NARKOMED 6000 TECHNICAL SERVICE BULLETIN # 6001

Product: Narkomed 6000

Re: Power cord routing

Reference Doc: ERN # 00-0783

Figure - 1 Power Cord Routing Detail

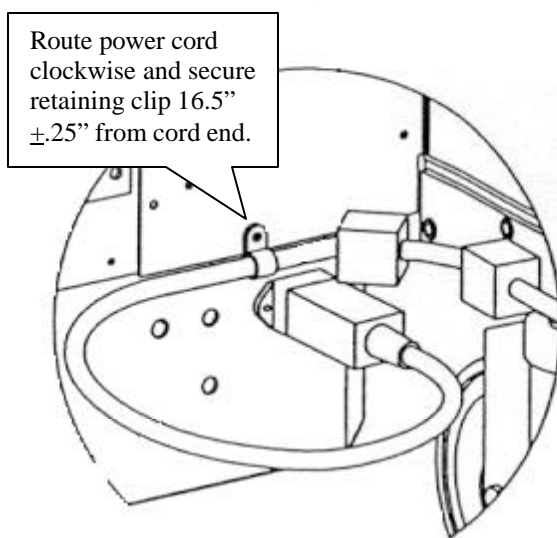
Reason/Rational: Document proper power cord routing to prevent unintended activation or deactivation of circuit breakers.

Solution/Procedure: Route the power cord's strain relief with a loop in a clockwise direction. The retaining clip shall to be located $16.5 \pm .250$ inches, (5.25 inch diameter loop approx.) from the cord end and secured to the Vitalbus HUB door using the mounting hole directly above the power cord socket. See attached illustration, Figure - 1. Refer to Narkomed 6000 Technical Service manual Replacement Procedures, Section - 4 for complete instructions.
